PACIFIC HIGHWAY AND WILSON STREET, CHATSWOOD | DESIGN INTEGRITY PANEL REPORT

APPLICANT RESPONSE TO RFI - ELEVATIONS AND 3D VIEWS

APPLICANT RESPONSE TO RFI - FAÇADE TREATMENTS AND DETAILED BASIX, NATHERS, ESD AND SECTION J TESTING

EAST ELEVATION

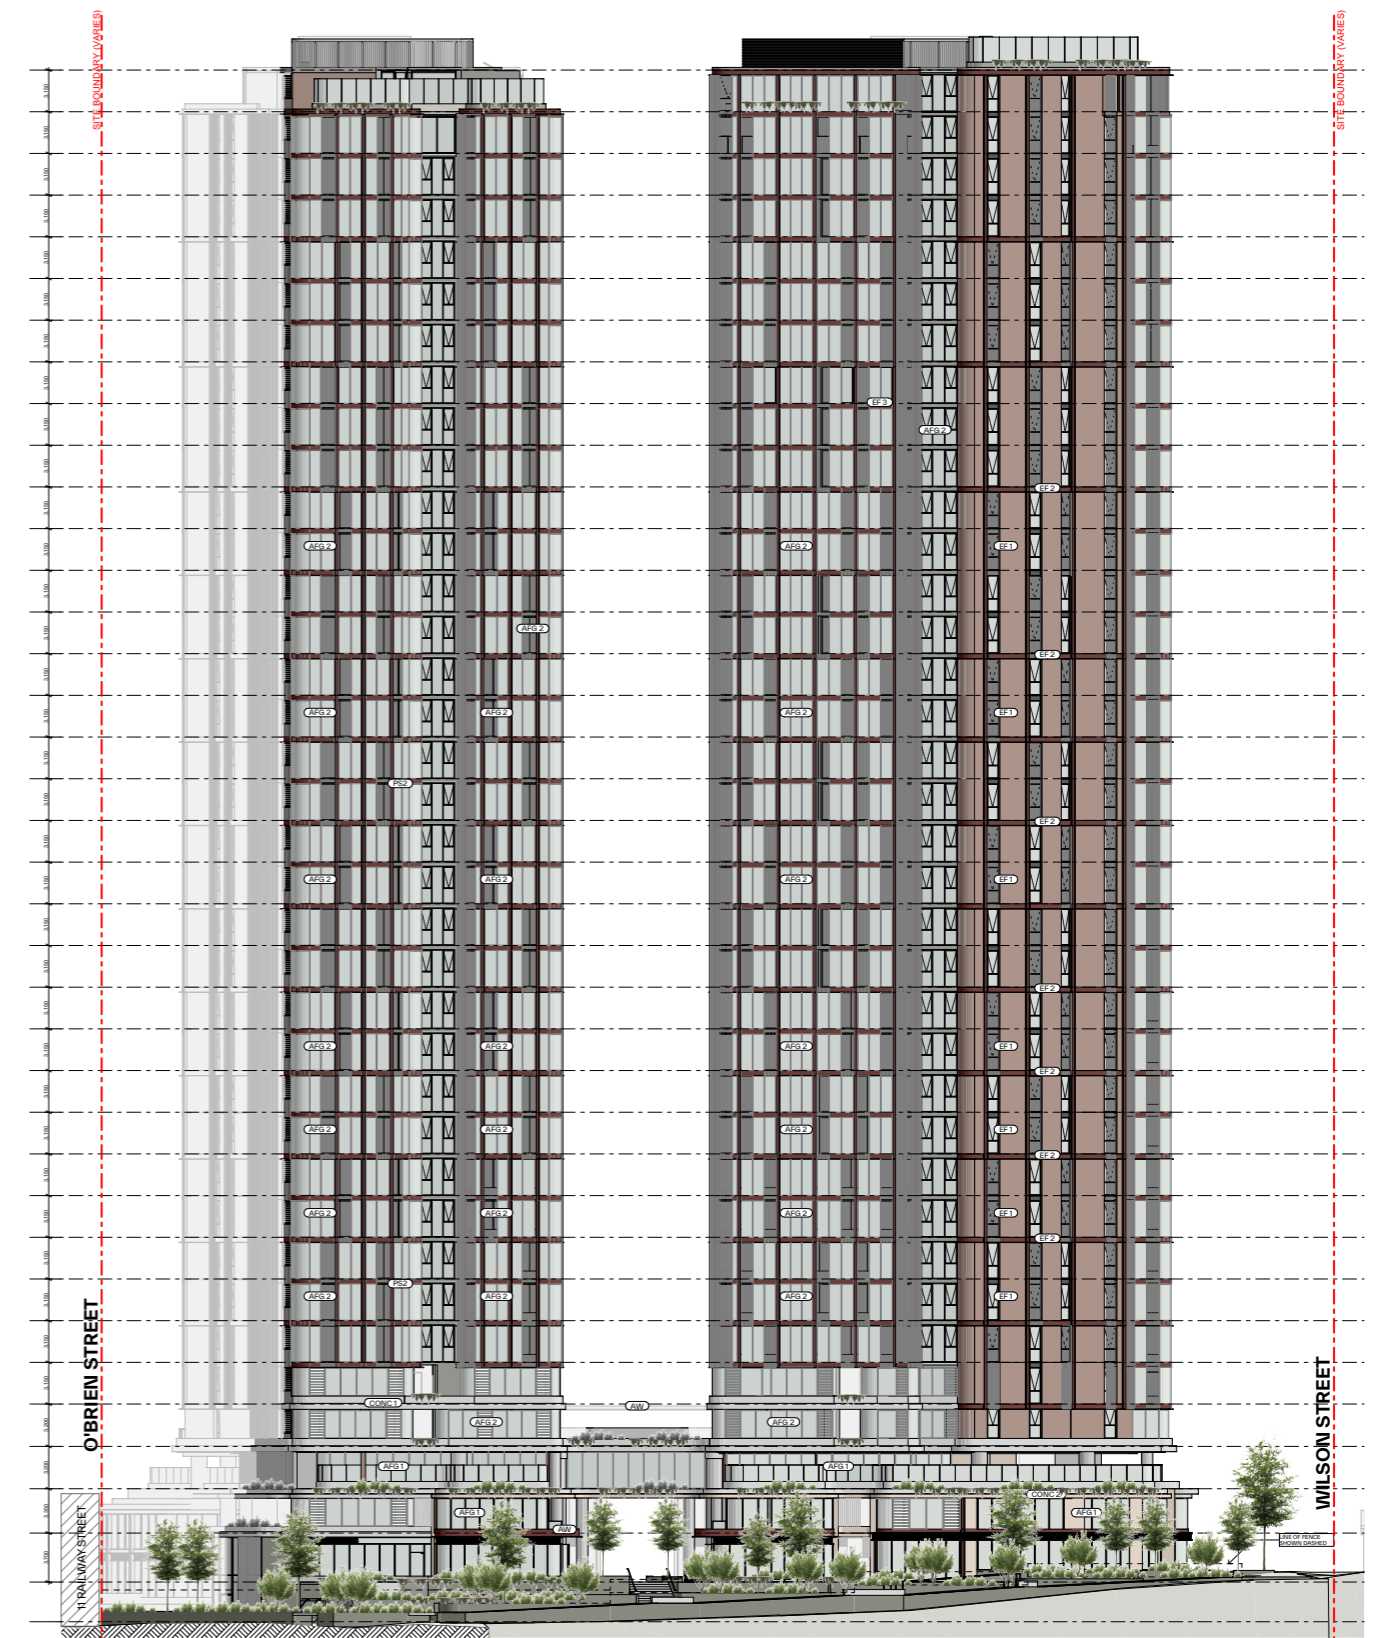
- Detailed descriptions and drawings that explain and illustrate:
 - How thermal comfort is maintained to the eastern and north-eastern apartments with the introduction of full height glazing and glazed louvres to comply with anti-throw requirements.

- How the visual impact of clutter/personal belongings within these enclosed balconies will be mitigated through solid spandrel elements or similar. This is particularly relevant for lower levels including the affordable housing dwellings when viewed from the public domain, rail corridor and surrounding urban context.

- How the quality and character of the eastern and north-eastern facades compliments the well-considered balance of solid and glazed elements evident in the western and southern facades.

Eastern Facade Balcony Treatment - Typical Level
Solid to void ratio calculation

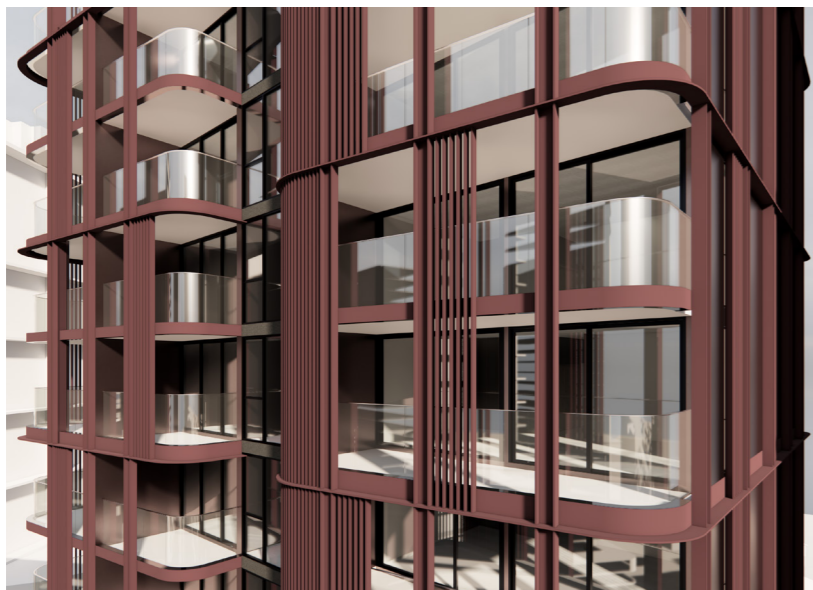
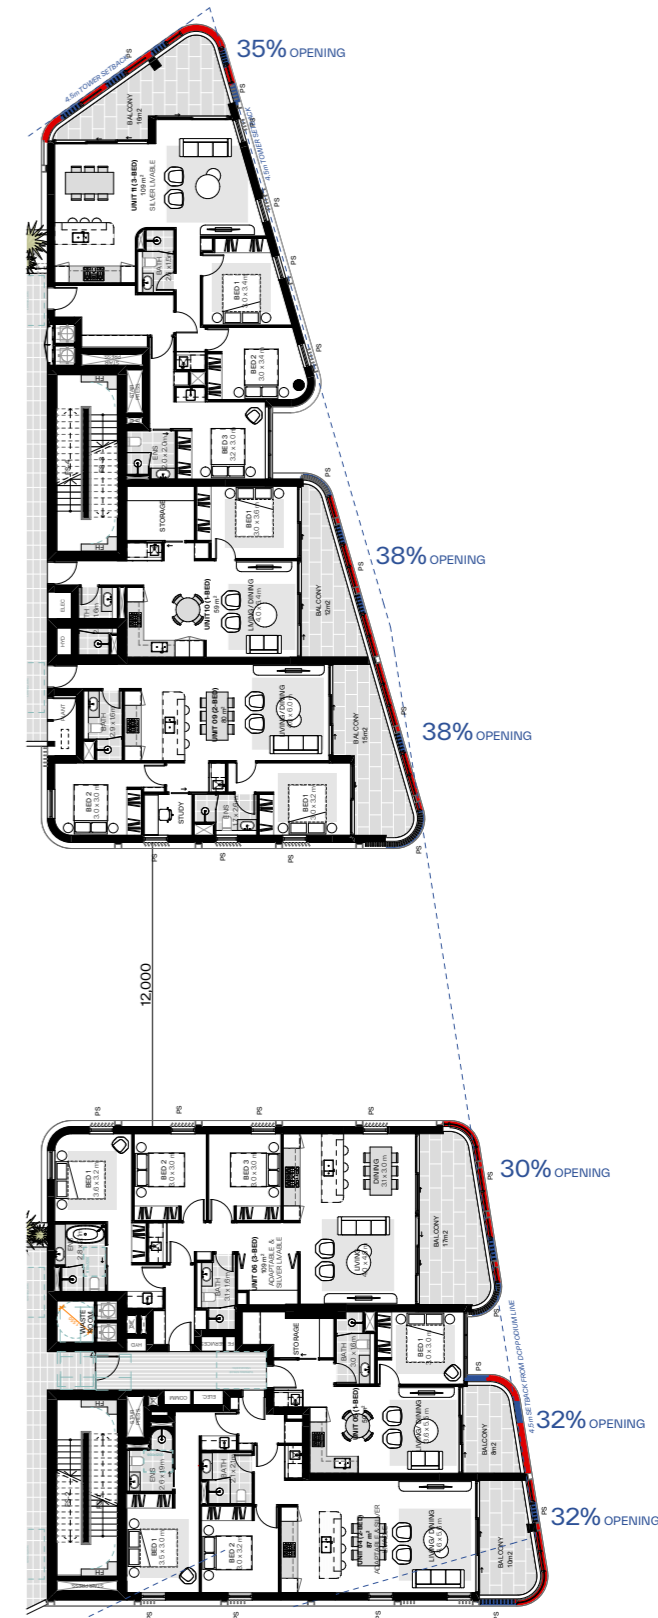
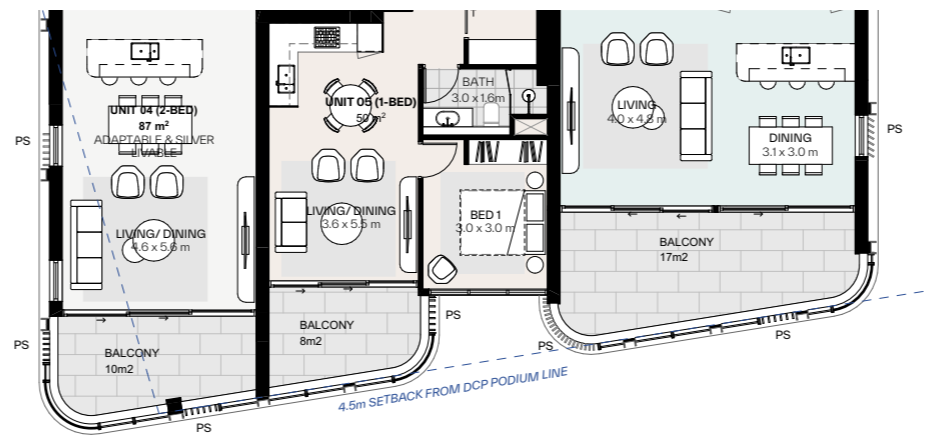
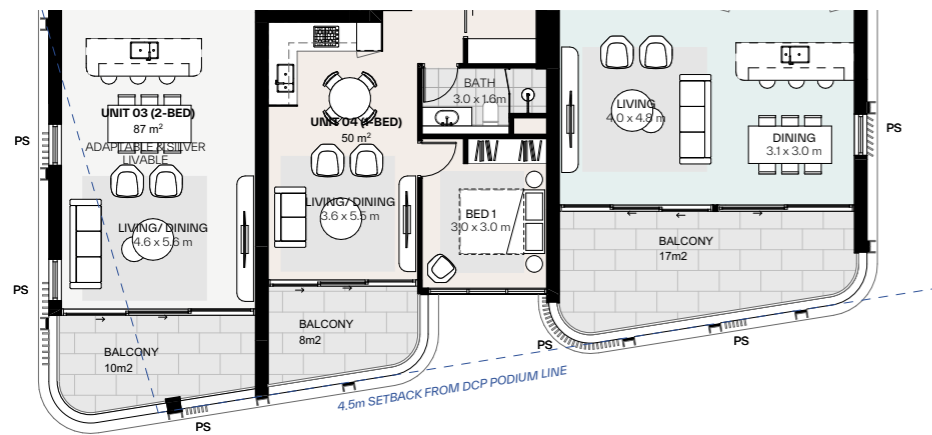
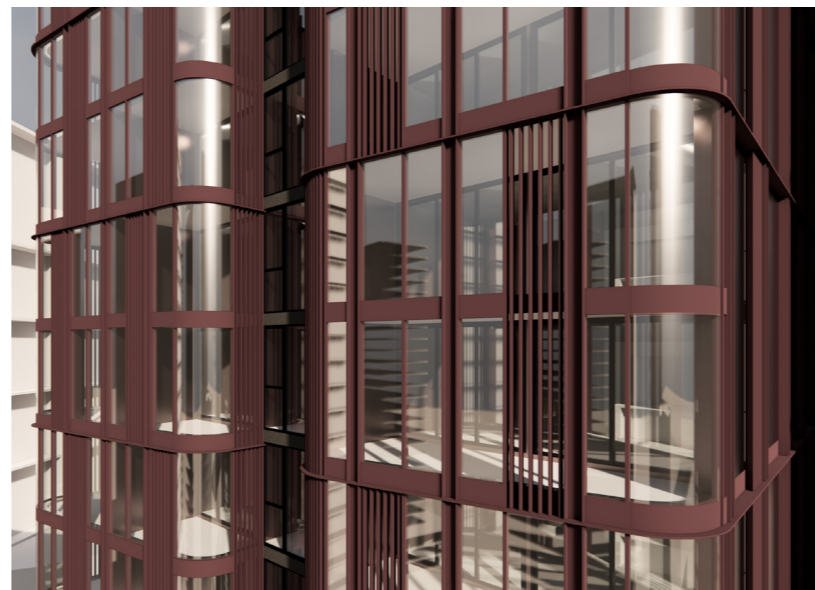
- Detailed descriptions and drawings that explain and illustrate:
 - how thermal comfort is maintained to the eastern and north-eastern apartments with the introduction of full-height glazing and glazed louvres to comply with anti-throw requirements.

- how the visual impact of clutter/personal belongings within these enclosed balconies will be mitigated through solid spandrel elements or similar. This is particularly relevant for lower levels including the affordable housing dwellings when viewed from the public domain, rail corridor and surrounding urban context.

- how the quality and character of the eastern and north-eastern facades compliments the well-considered balance of solid and glazed elements evident in the western and southern facades.

Treatment to Eastern Facade Balconies

Transport for NSW has established design requirements that outline standards for the interface between developments and rail corridors. Several changes have been made to the design excellence scheme on the eastern and north-eastern facades to comply with these requirements.

On these facades, within 20 meters of the rail corridor boundary, balconies now feature a combination of full-height fixed glazing, vertical aluminium louvers, and horizontal glass louvers (to the podium levels). This design approach adheres to the standards by limiting the maximum opening sizes to minimize potential throw risks to the rail corridor, whilst providing a substantial fixed open component, to prevent full enclosure of any balconies and maintain natural ventilation. Additionally, childcare and rooftop open spaces on the eastern facade include 1.8-meter-high glass balustrades.

These changes have been carefully implemented to comply with the guidelines while maintaining the original design intent of the excellence scheme.
